Product Change Notice (PCN)

PCN Number: PCN-0450480R-01

Product(s) Affected: *MJ-3507*

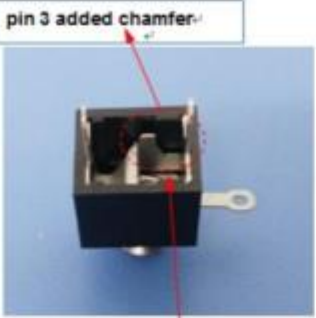
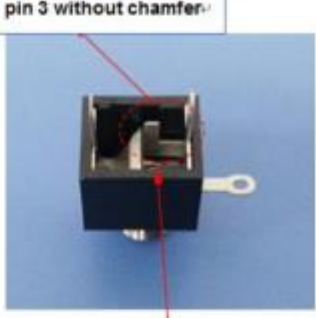
Reason(s) for Change: *The existing mold of pin 3 for MJ-3507 is unable to maintain efficient production. To ensure the quality and lead-time of production, a re-development of the mold has been processed. The new mold will optimize the design by increasing the chamfer of pin 3 inside the product. The electrical structure and function will remain the same. (The comparison photos are available below).*

New version	Current version
Back	 <p>pin 3 added chamfer</p>	 <p>pin 3 without chamfer</p>
	 <p>pin 3 is continuous piece, with cutting mark</p>	 <p>pin 3 is separate piece, without cutting mark</p>
	 <p>pin 3 added chamfer</p>	 <p>pin 3 without chamfer</p>
